FED. ROAD DIST. NO.	STATE	FED. AID PROJ. NO.	FISCAL YEAR	SHEET NO.	TOTAL SHEETS
HAWAII	HAW.	M-7600(1)	1978	22	198

GRADING, DRAINAGE & CONSTRUCTION PLAN
FORT WEAVER ROAD
STA. 57+77.64 TO STA. 70+00.00

GRADING, DRAINAGE & CONTRUCTION PLAN
FORT WEAVER ROAD
STA. 70+00.00 TO STA. 85+00.00
FORT WEAVER ROAD
ROUTE H-1 TO SOUTH OF
FARRINGTON HIGHWAY

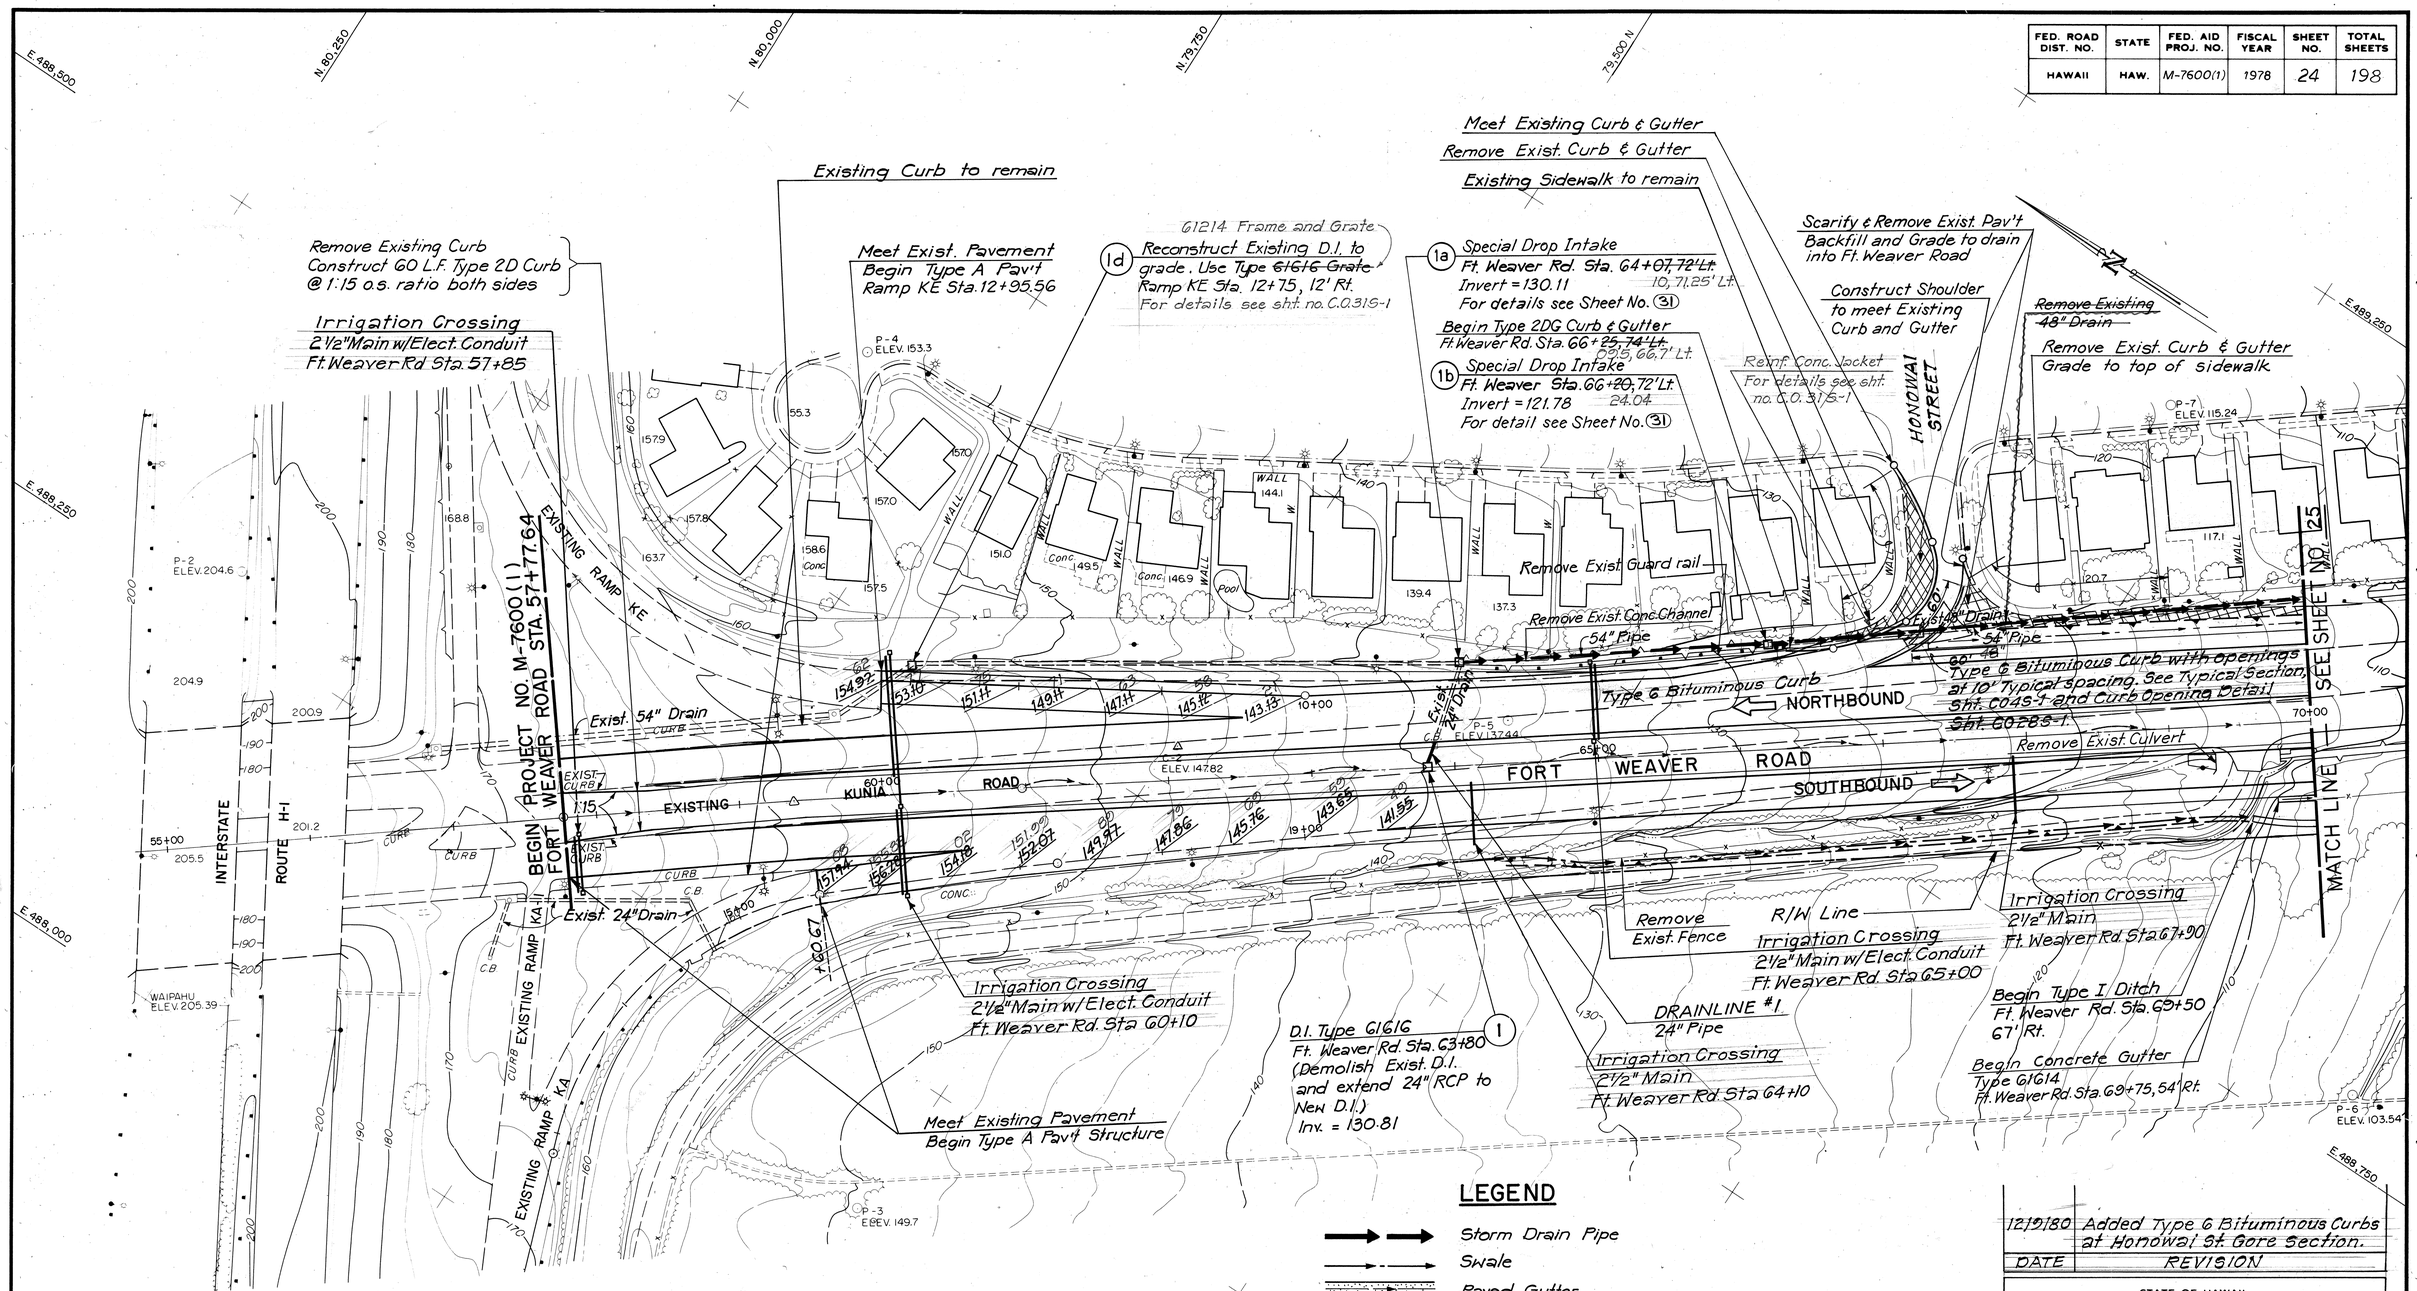
DATE	REVISION
12/19/80	Added Type G Bituminous Curbs at Honowai St. Gore Section.

GRADING, DRAINAGE & CONSTRUCTION PLAN

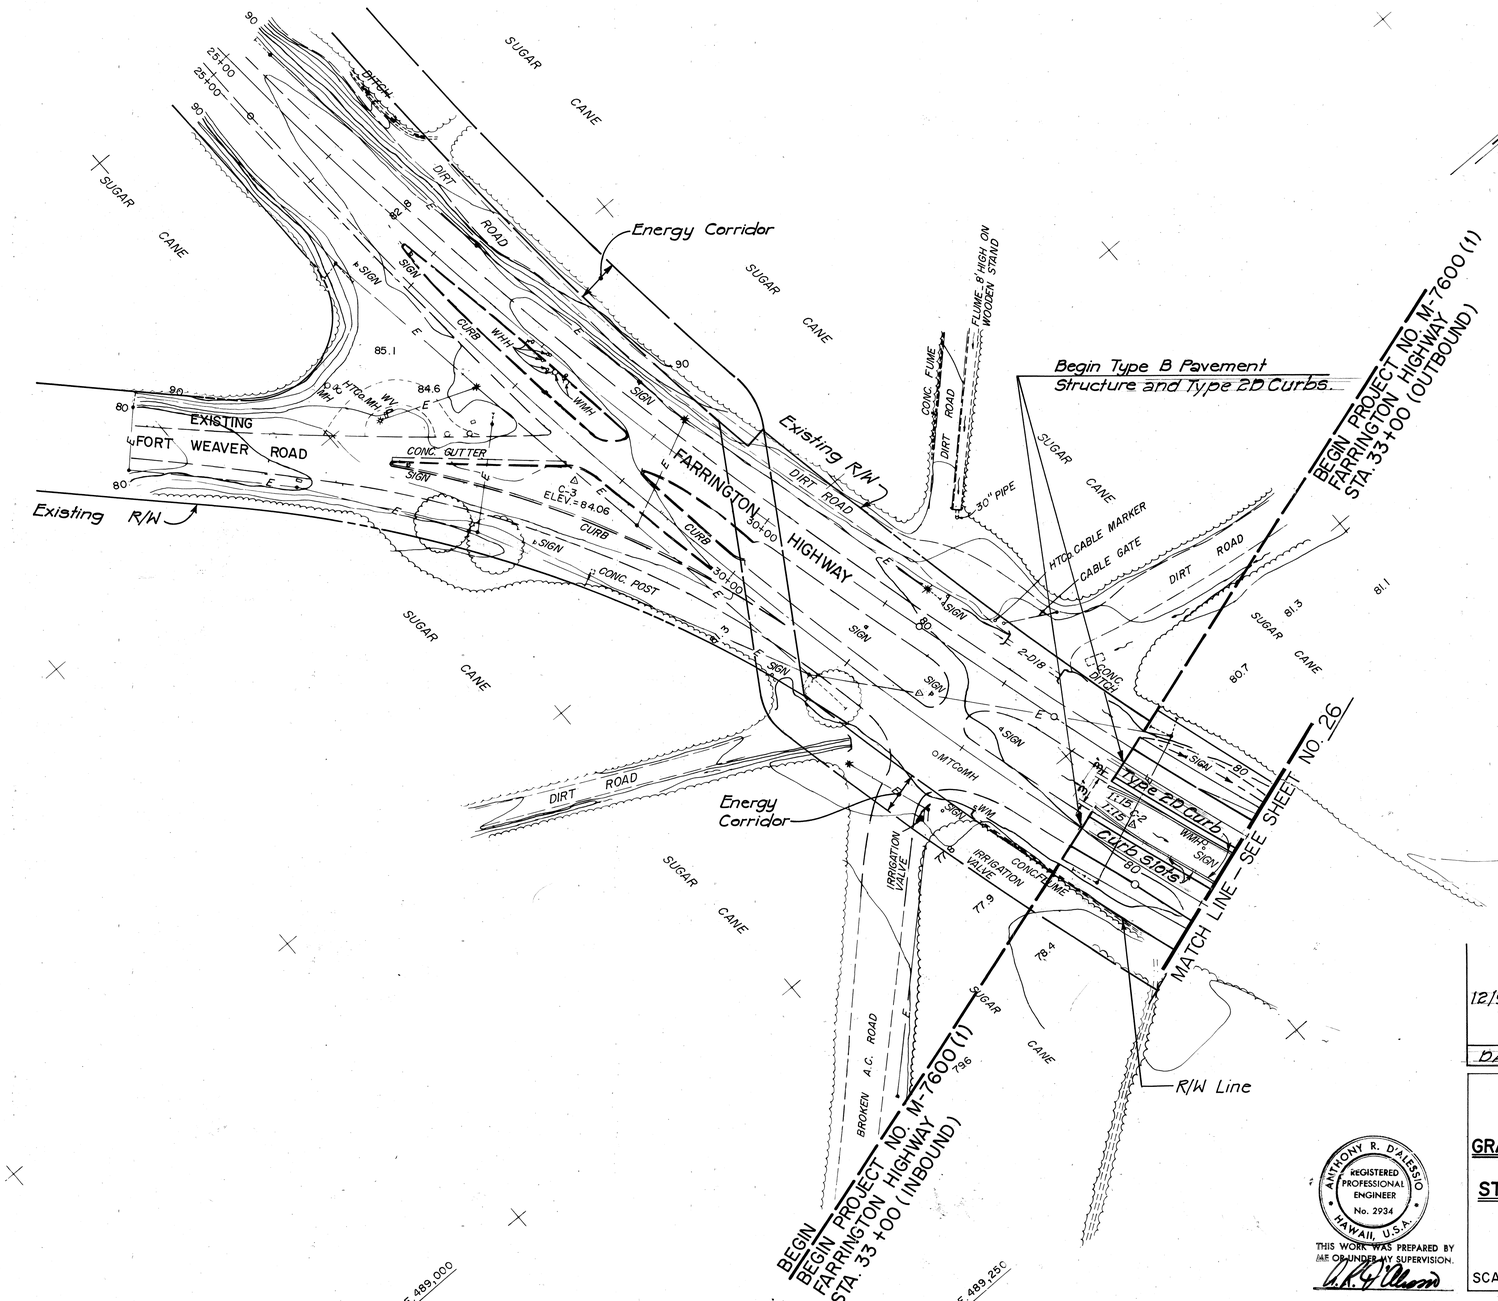
DATE	REVISION
12/0/80	Added Type 2D Curbs to Farr. Hwy. Median from Sta. 33+00 to Sta. 34+00.

GRADING, DRAINAGE & CONSTRUCTION PLAN
FARRINGTON HIGHWAY
STA. 51+00.00 TO STA. 56+30.00

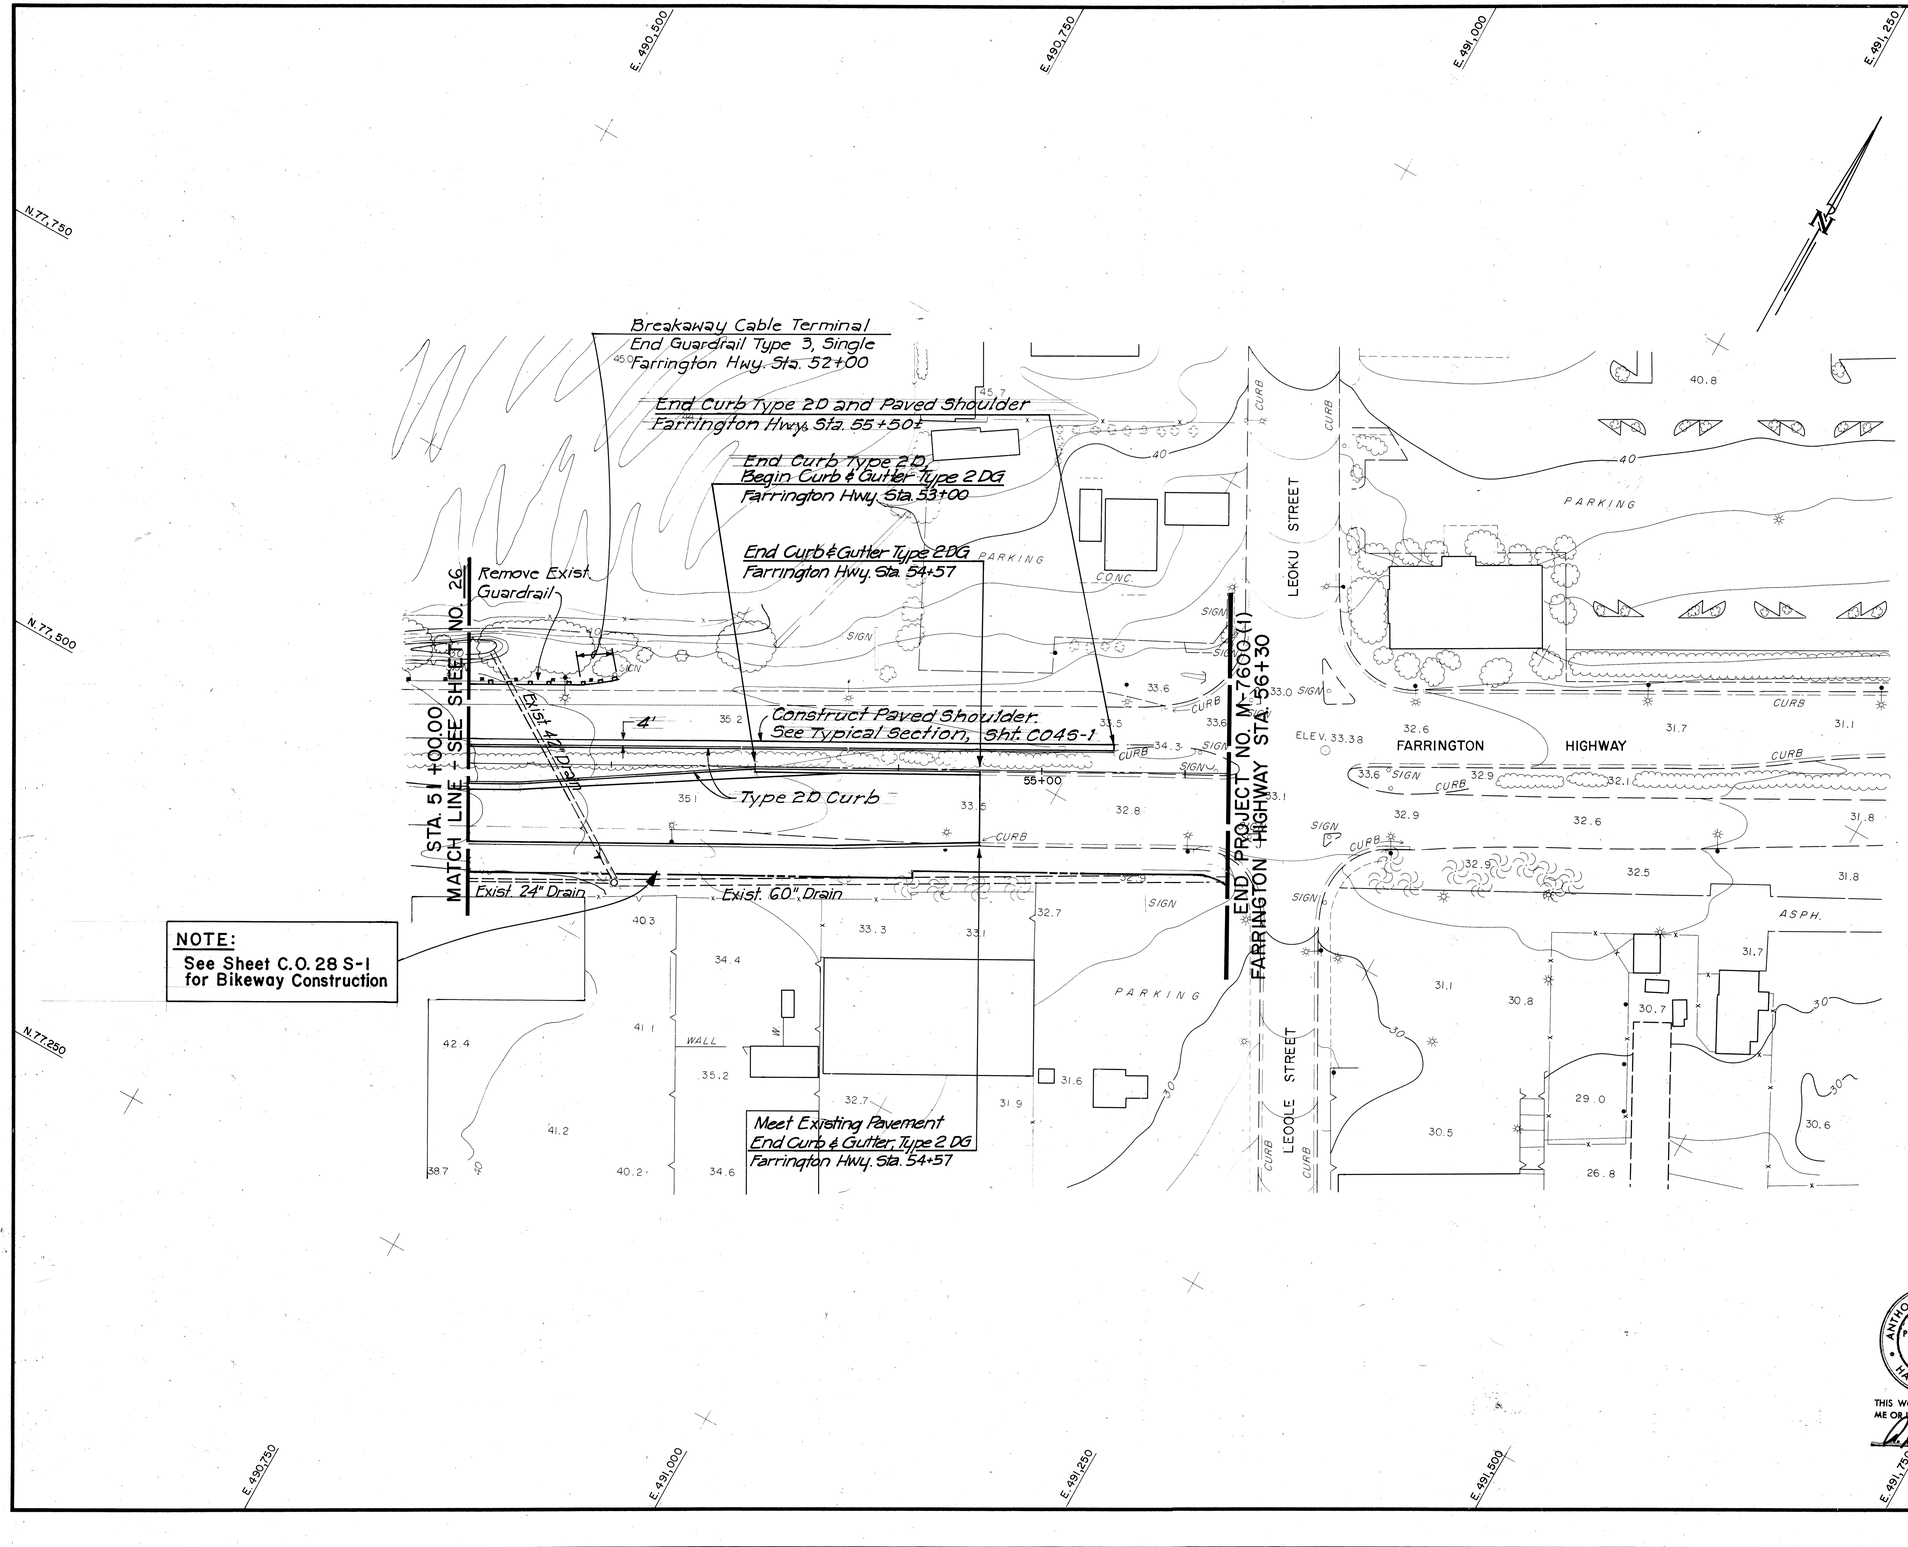
DATE	REVISION
12/10/80	Added Type 2D Curbs to Farr. Hwy. Median. Added Paved Median Shoulder to Farr. Hwy. Outbound Lanes.
9/7/79	Deleted Bikeway. Added Reference Note for New Bikeway Construction.

BIKEWAY PLAN
FORT WEAVER ROAD ROUTE H-1 TO SOUTH OF FARRINGTON HIGHWAY

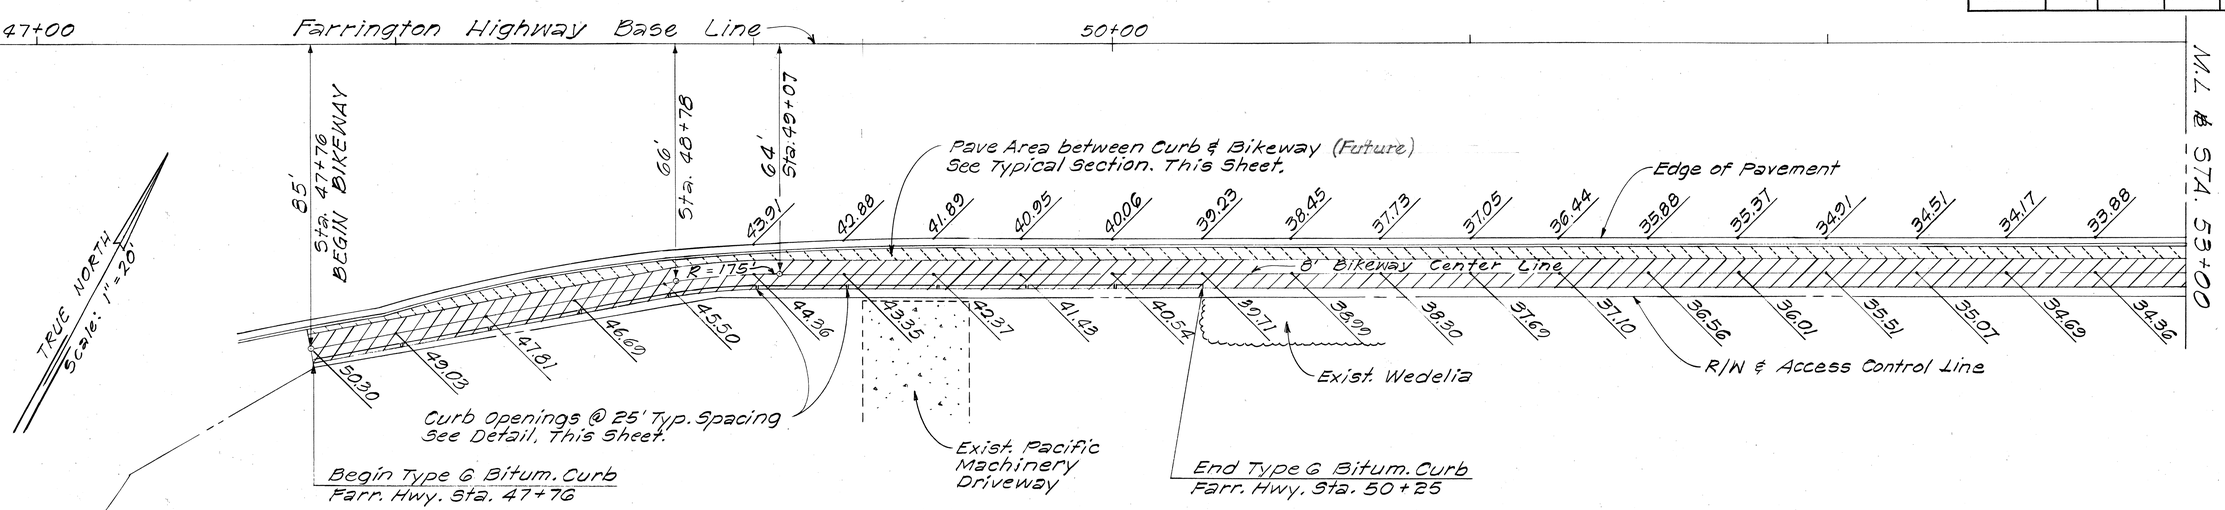
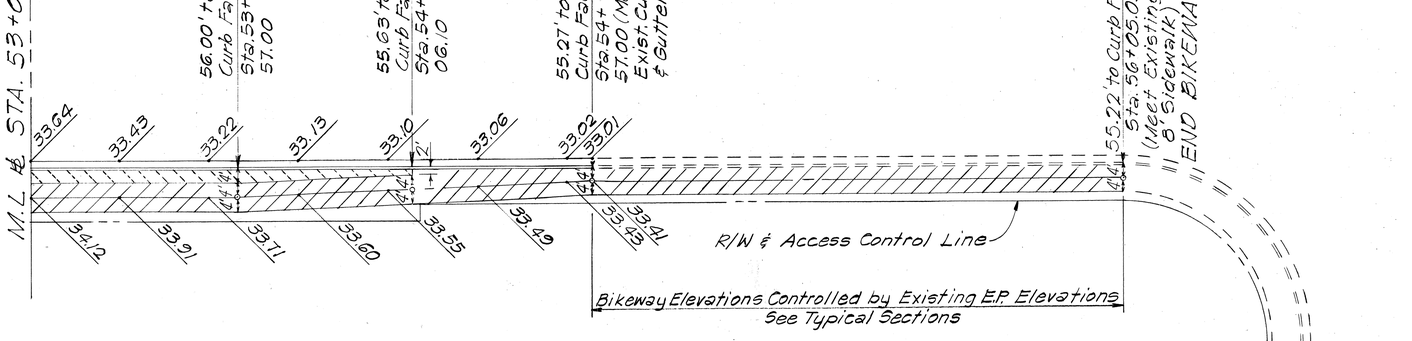
DATE	REVISION
12/9/80	Added Bituminous Curb along Edge of Bikeway. ~~Added~~ Paving between Farr. Hwy. Curb and Bikeway, (Future)

DRAINLINE #1

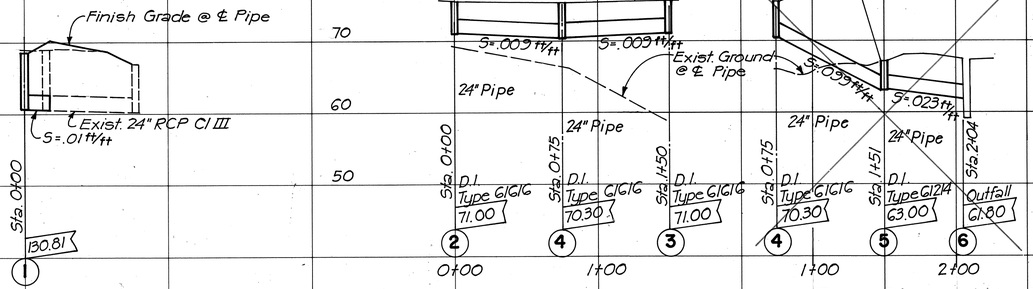
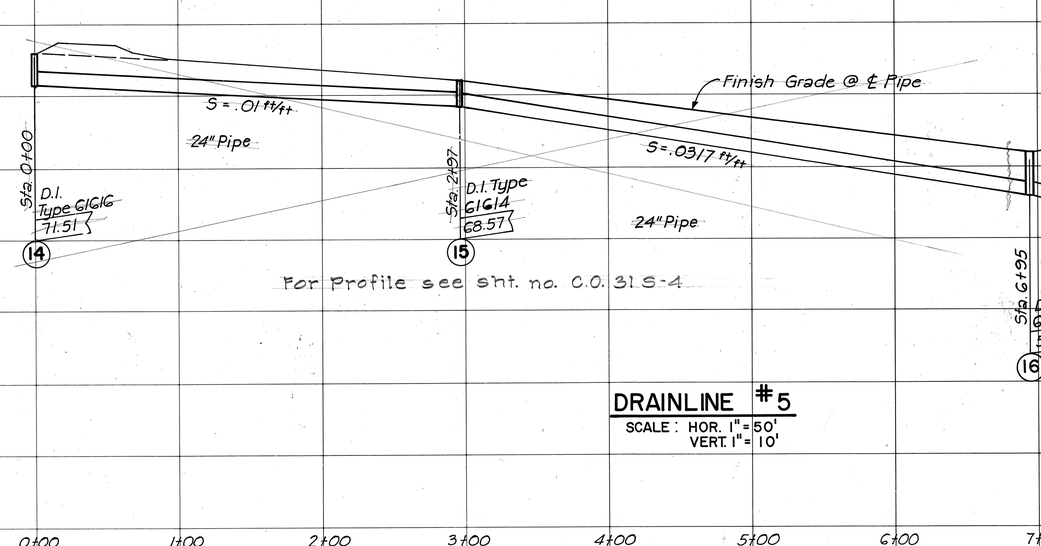
Date	Revision
1-12-79	Revised Notes on Drainline #3 as per Addendum No. 1.
